ADDENDUM NO. 2, APRIL 23, 2009

RE: Ocean Avenue Elementary School  
Portland, Maine  
A/E Comm. No. 3316.10

City of Portland RFP No. 7109  
BGS project No. 723

SCALE:	N.T.S.
WBRC CAD FILE:	
PROJECT No.	3316.10
JOB CAP/DRAW:	RMC
PM:	MEJ
CHECKED BY:	AAH
DATE:	4/23/09
SHEET No.	ADD2-CU101-1
© COPYRIGHT 2009 WBRC

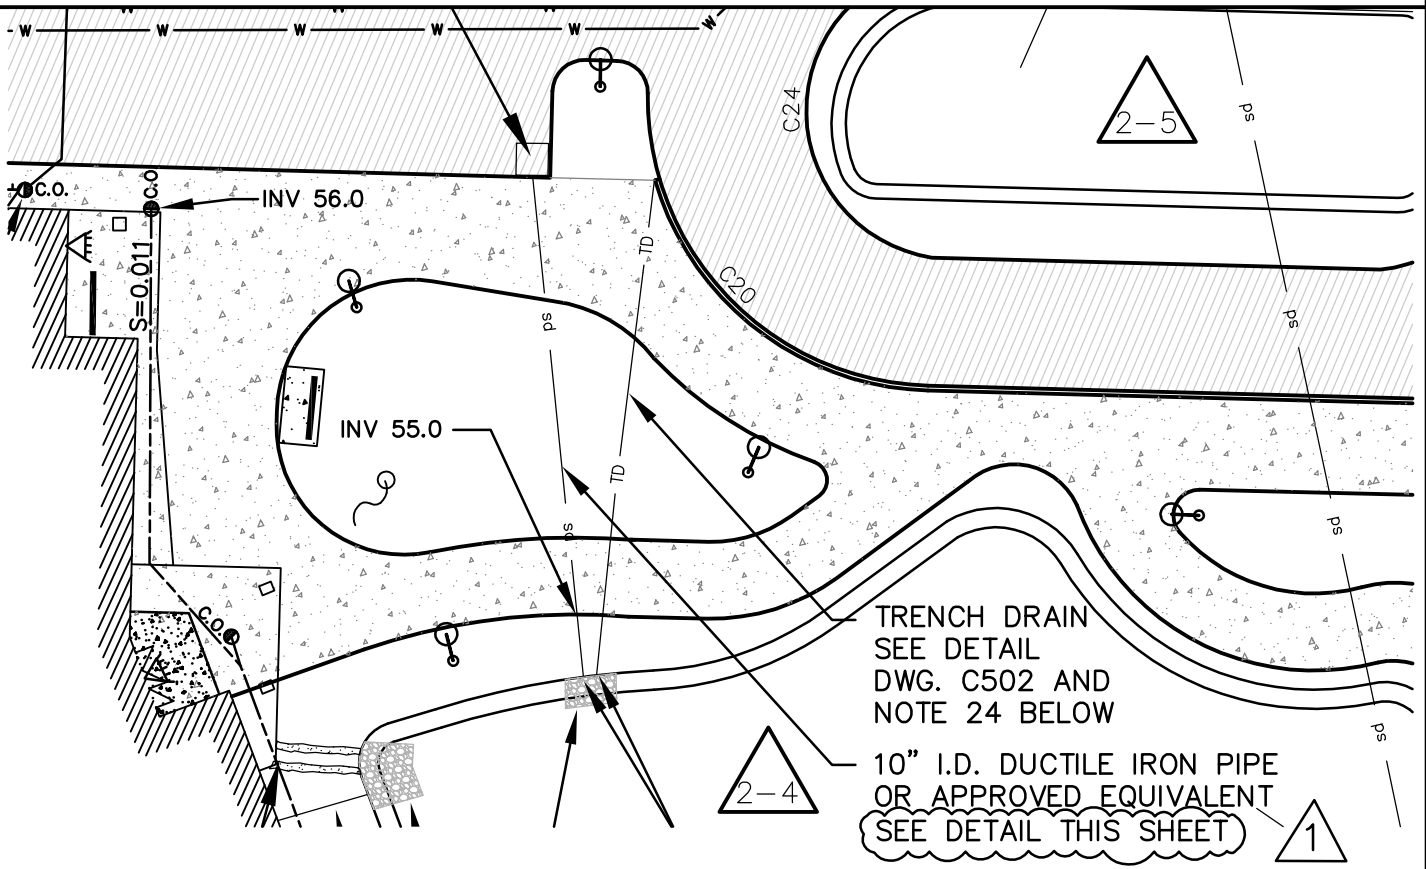
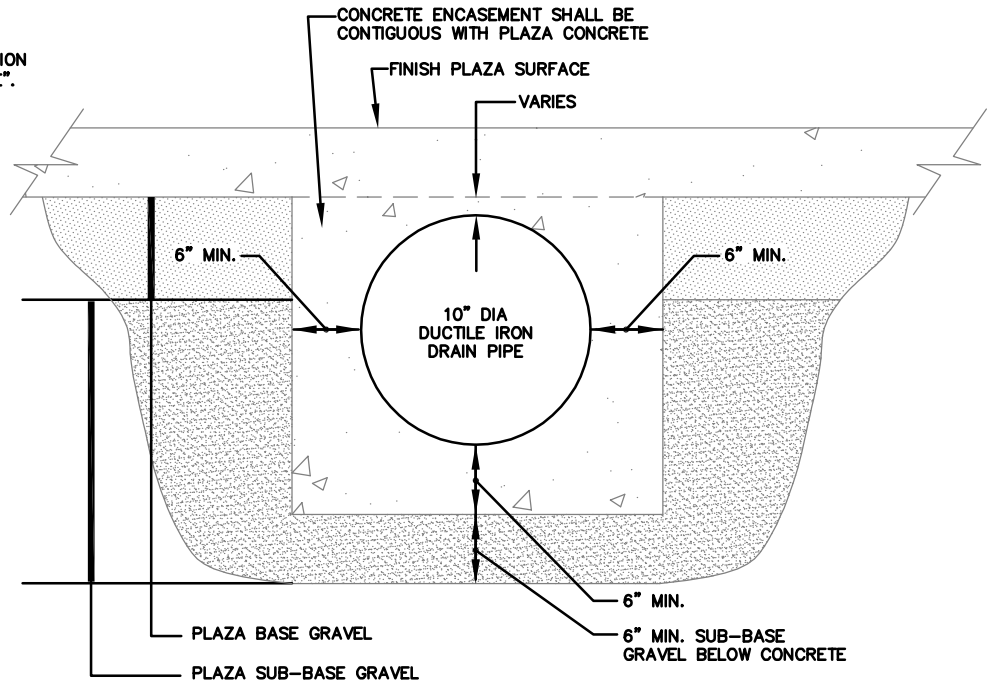
25. Sheet CU101, Site Utility Plan:
- Utility Legend Notes, Item F, DELETE in its entirety and REPLACE with the following:  
 “F. Electrical transformer and other site electrical infrastructure – Electrical contractor is responsible for the purchase and preparation of structures, and for the installation of the conduit. Site contractor is responsible for excavation, bedding, installation, and backfilling of all electrical structures. Site contractor shall be responsible for excavation, required bedding for structures, and backfilling of all electrical trenches. In addition, site contractor shall place the required concrete encasement around the conduit in paved areas to meet Central Maine Power Company specifications. Concrete is specified in Division 03 Section “Cast in Place Concrete”. See site electrical plans ES101 and ES501 for more information about the layout and structures required.”

- REVISE portions as indicated on Sketch ADD2-CU101-1.
26. Sheet AE101-C, First Floor Plan Segment C:
- REVISE portions as indicated on Sketch ADD2-AE101-C-1. Directly adjacent to each boxed out column in all four “Ed Tech Small Group” areas, is a space too small for a scheduled locker. Provide a filler panel at this location to match adjacent locker material. This revision will be similar at drawings AE101-B, AE102-B, and AE102-C.

CHECKED BY: MEJ ADD2-AE208-1

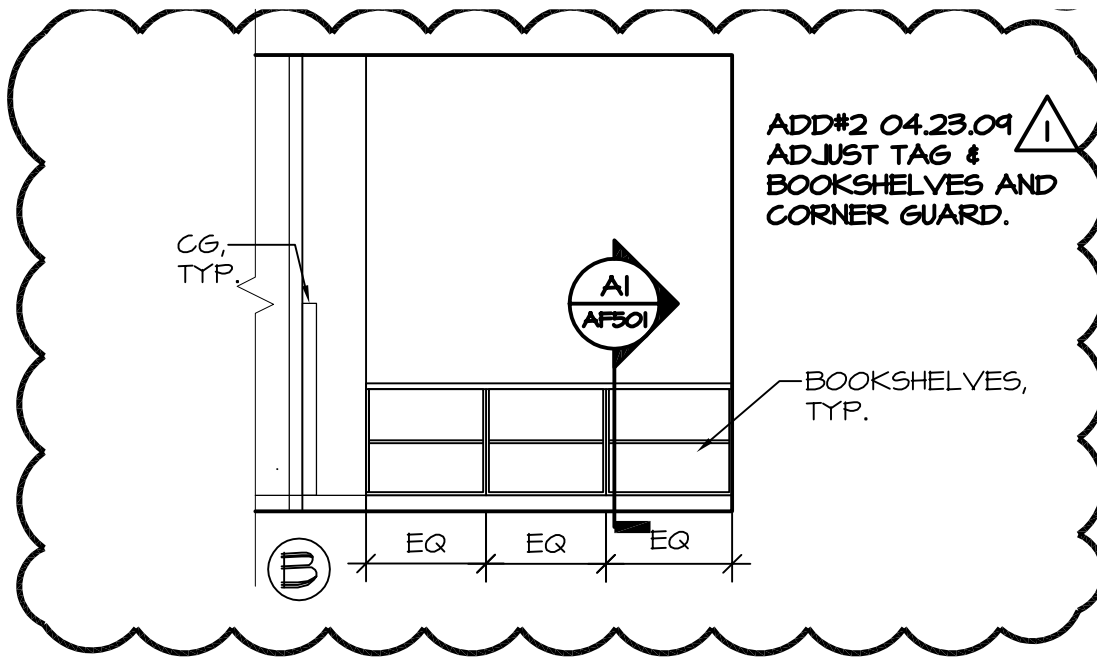
27. Sheet AE208, Interior Elevations, REVISE portions as indicated on Sketch ADD2-AE208-1.
28. Sheet AE214, Interior Elevations, Detail F1, Computer Lab #147, CHANGE two of the tackboards in this space to markerboards, the center visual display board at elevation ‘D’ and the northern most visual display board at elevation ‘B’. Total visual display boards for this space includes two markerboards and three tackboards, all 4’-0” x 8’-0”.

SCALE:	1/4" = 1'-0"	
WBRC CAD FILE:	3316.10	
PROJECT No.	3316.10	
JOB CAP/DRAW:	TRJ	
PM:	MEJ	SHEET No.
CHECKED BY:	MEJ	ADD2-QF101-1
DATE:	04-23-09	© COPYRIGHT 2009 WBRC

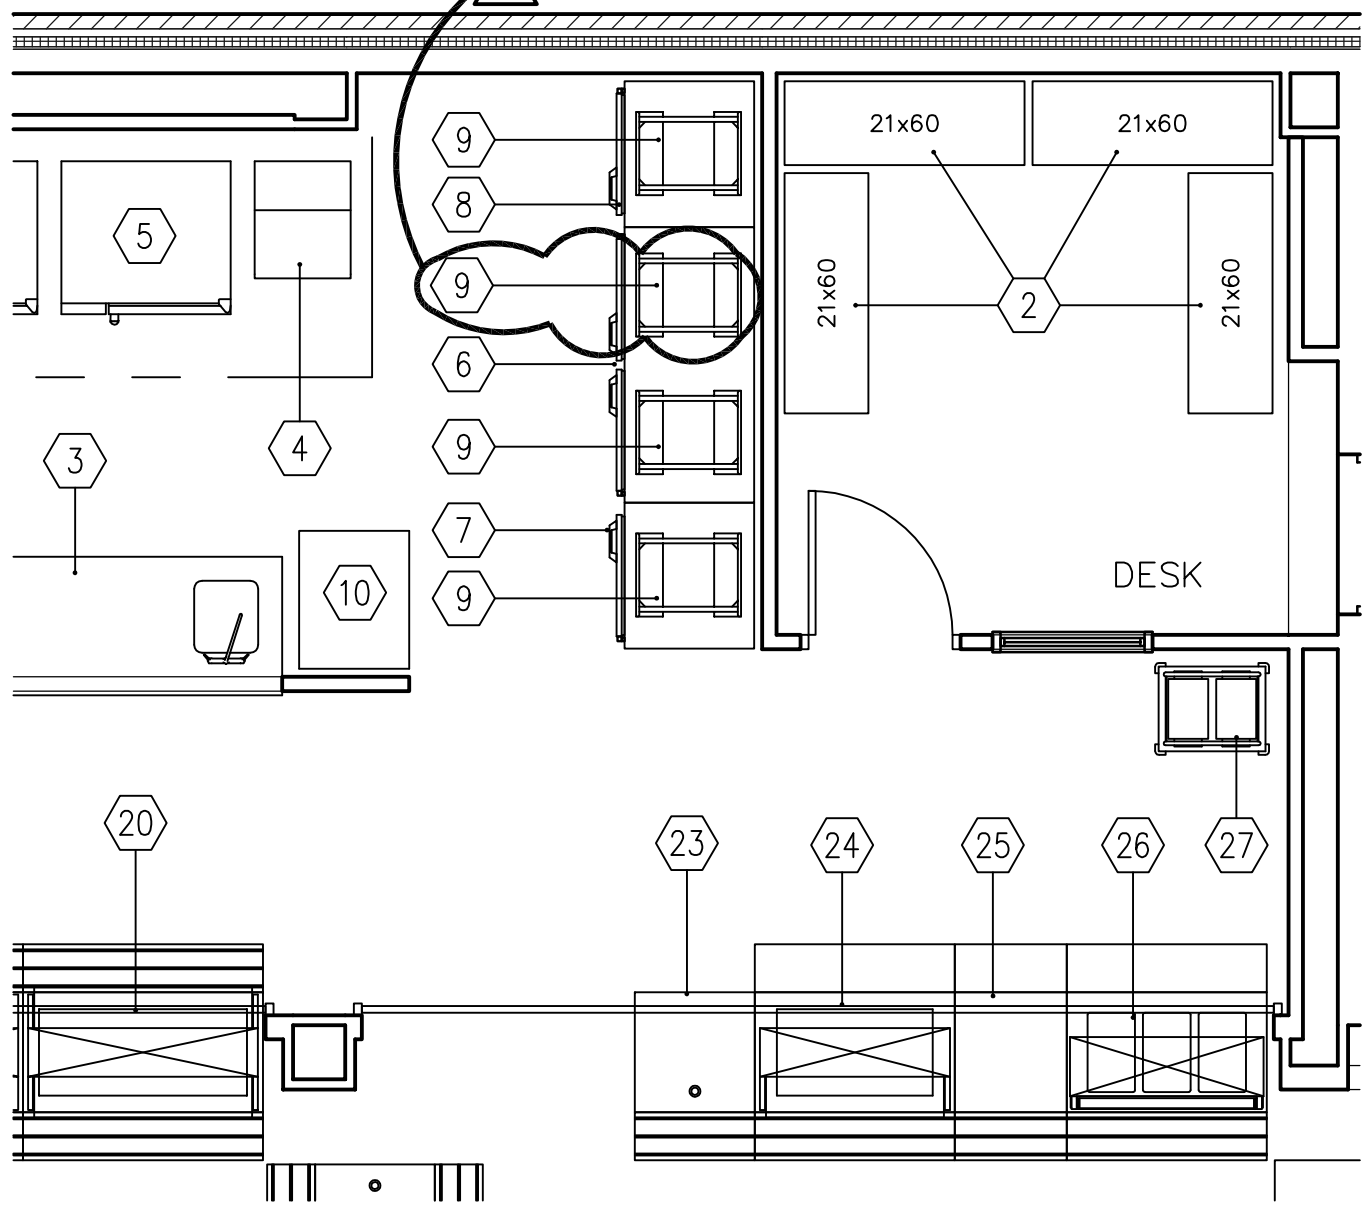
31. Sheet AE601, Door and Frame Schedule and Types, REVISE door and frame schedule as follows: Door E108C change door type from ‘C’ to ‘A’.
32. Sheet QF101, Kitchen Equipment Plan, REVISE portions as indicated on Sketch ADD2-QF101-1.

**ADD2-ES101-1**

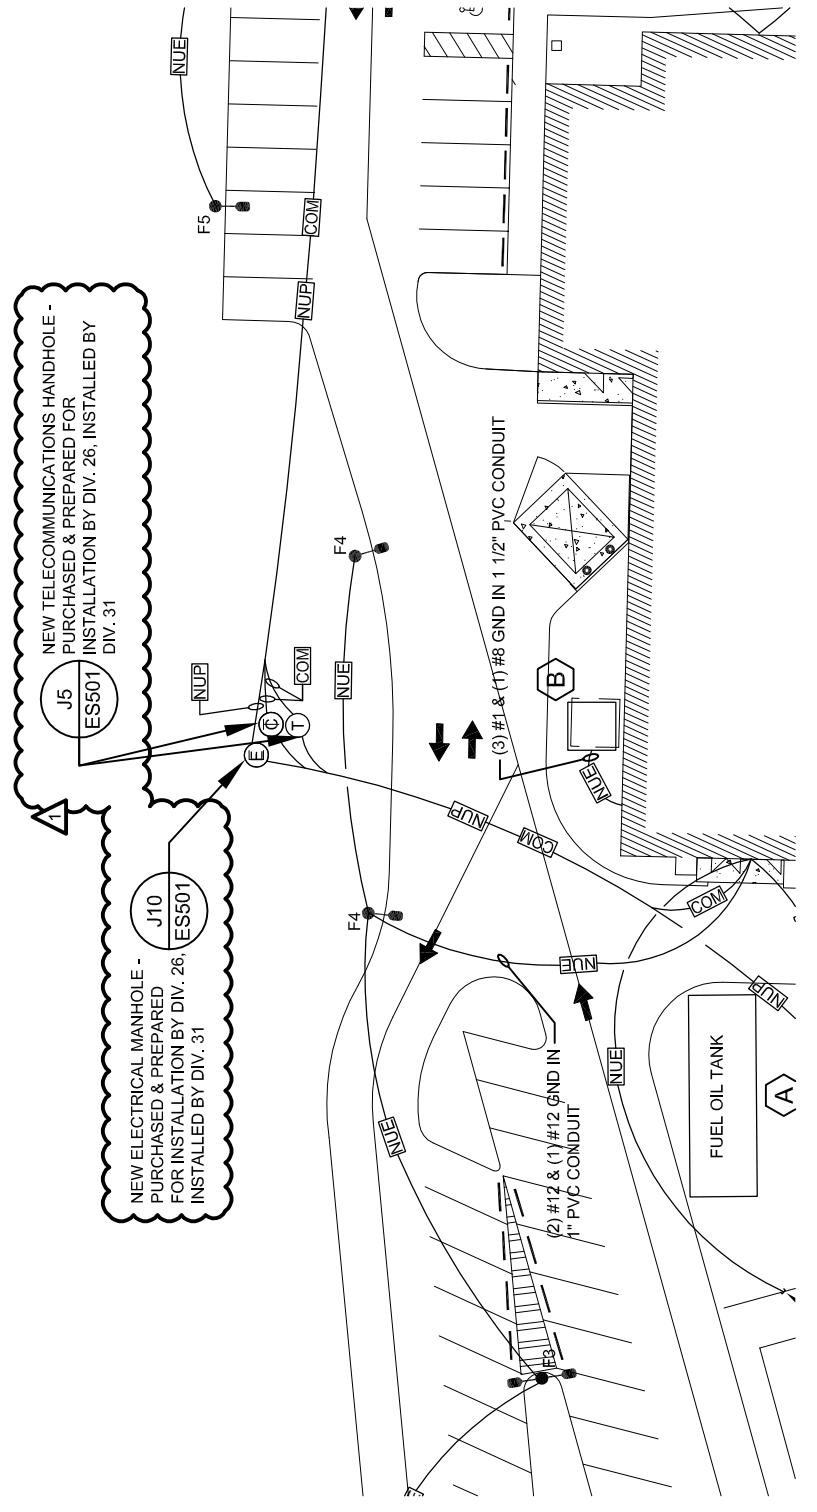
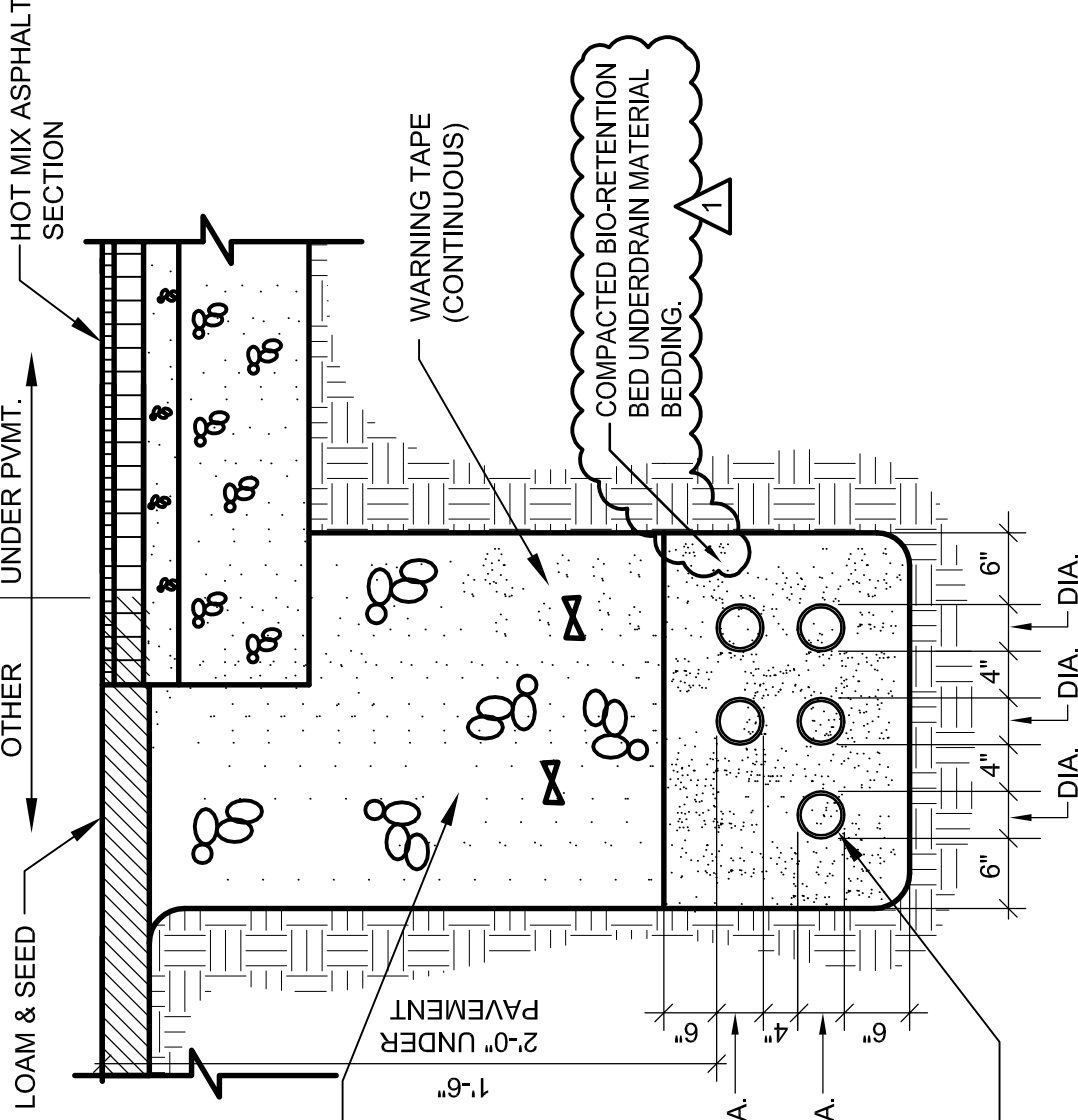
33. Sheet ES101, Site Electrical Plan:
  - ADD the following to the Site Abbreviations: “COM shall indicate Underground communications.”
  - REVISE portions as indicated on Sketch ADD2-ES101-1.

**ADD2-ES501-1**

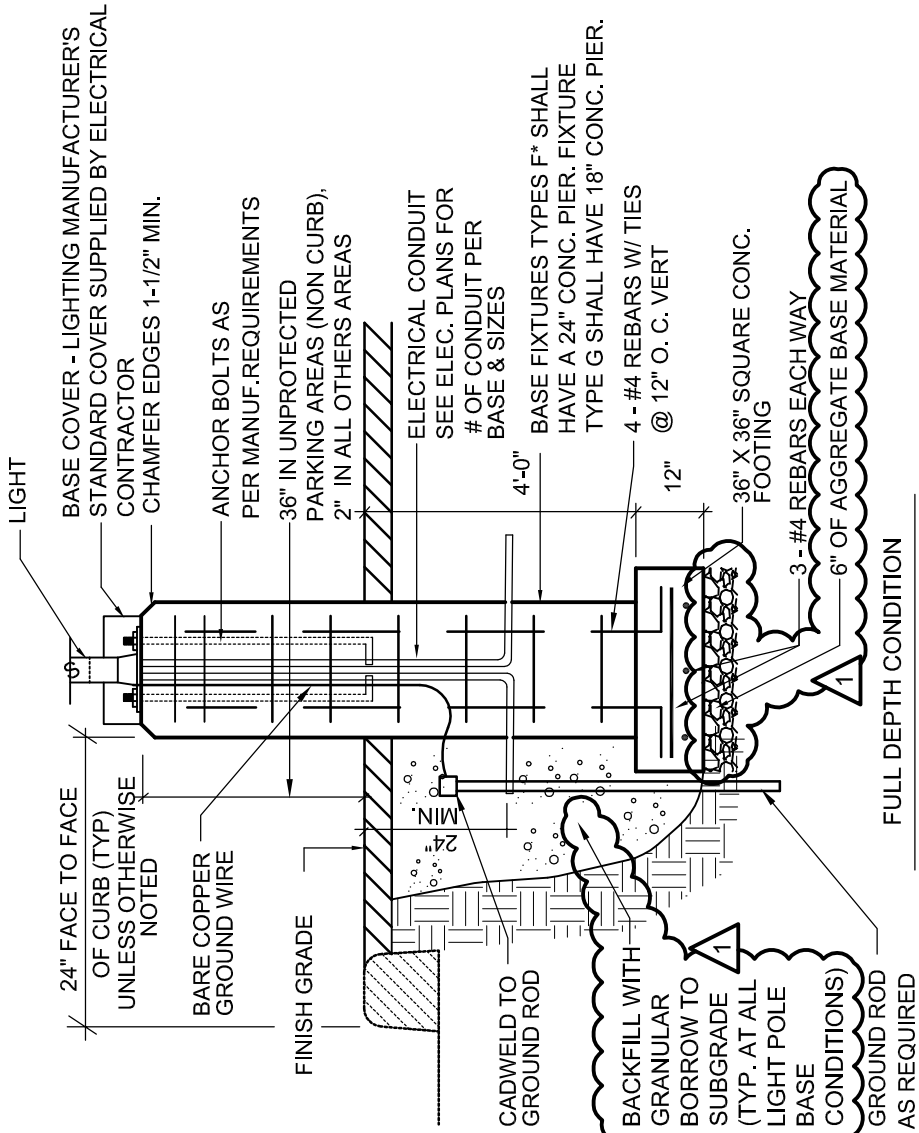
34. Sheet ES501, Site Electrical Details:
  - Detail A5, REVISE portions as indicated on Sketch ADD2-ES501-1.
  - Detail A10, REVISE portions as indicated on Sketch ADD2-ES501-2.

ADD2-EP101-C-1

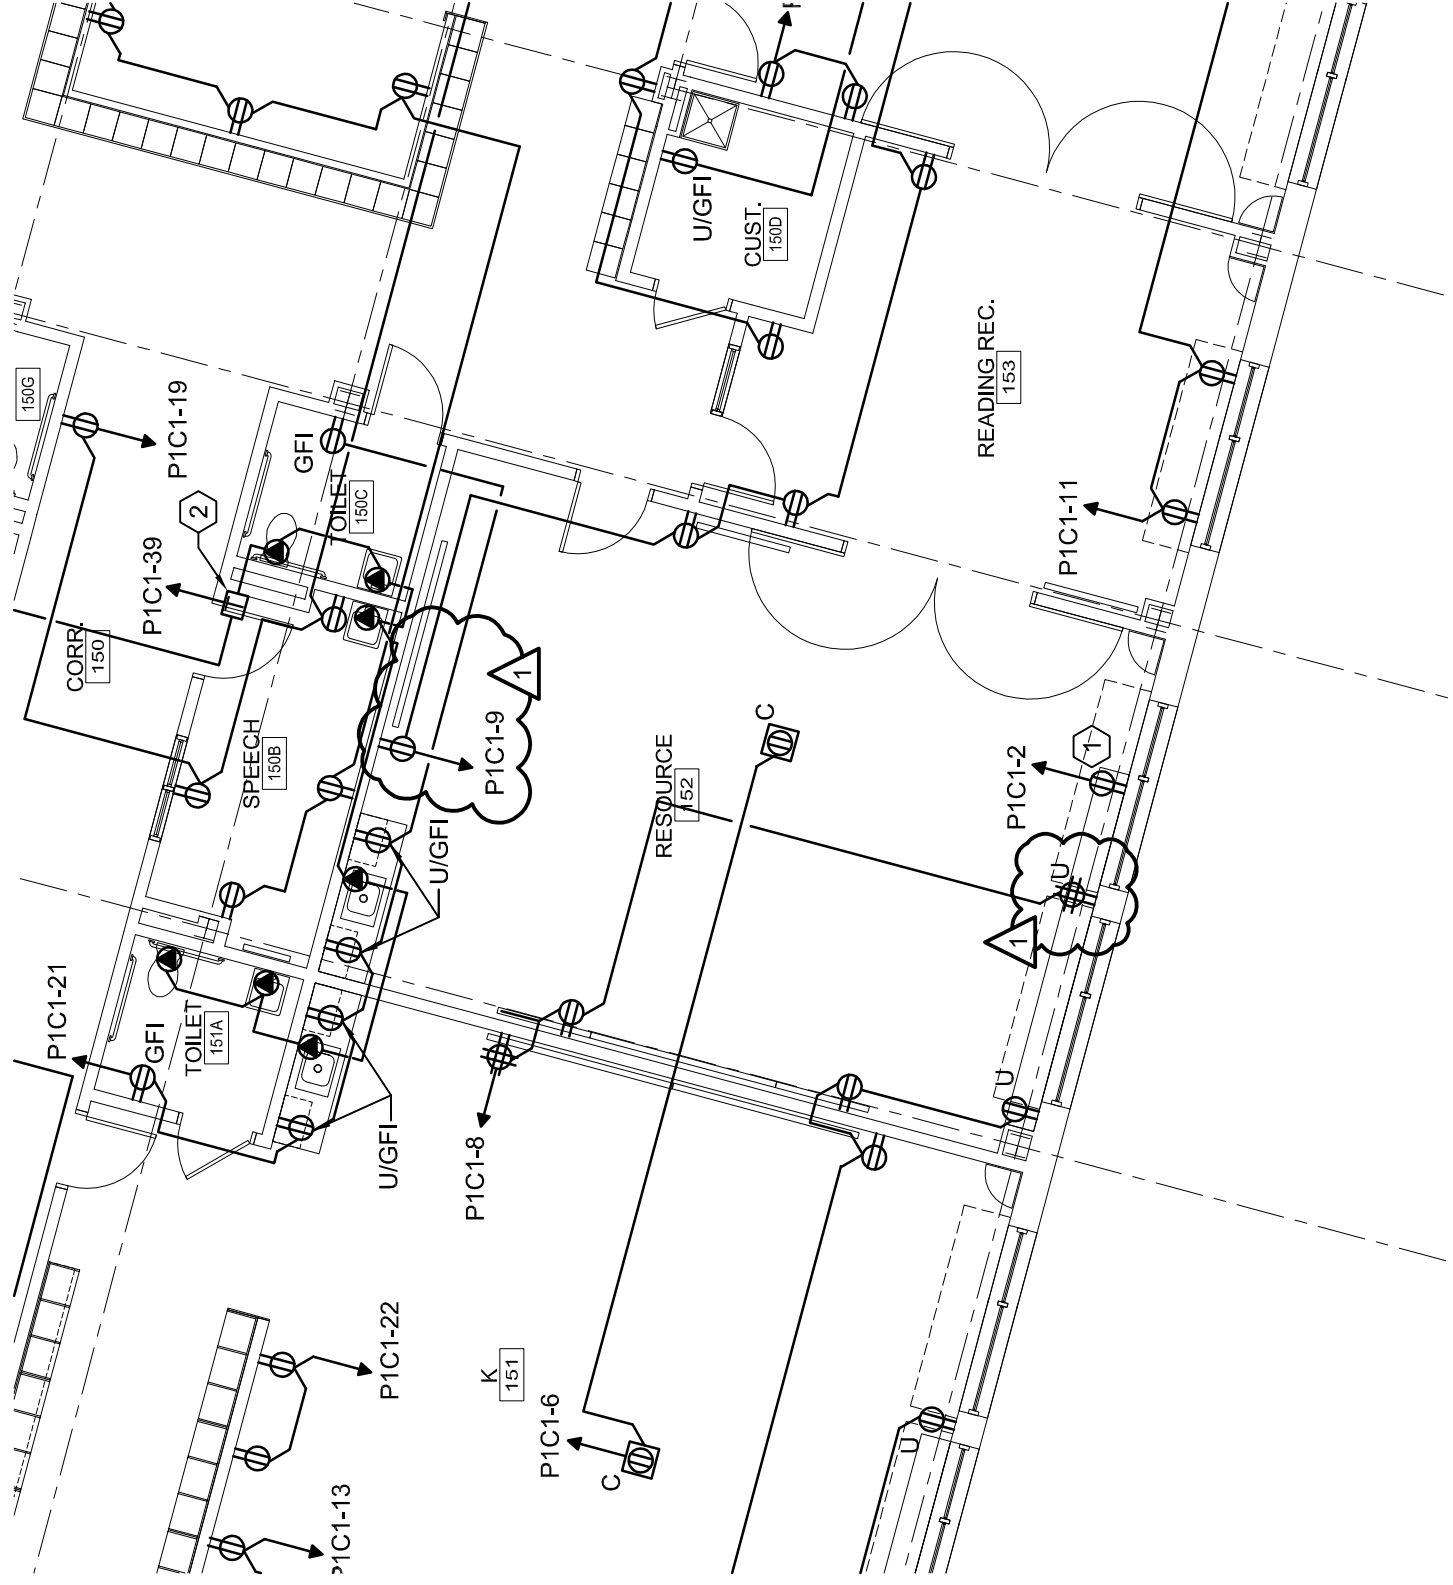
36. Sheet EP101-C, First Floor Electrical Power Plan – Seg. C, REVISE portions as indicated on attached Sketch ADD2-EP101-C-1.
37. Sheet EP102-B, Second Floor Electrical Power Plan – Seg. B, REVISE portions as indicated on attached Sketch ADD2-EP102-B-1.
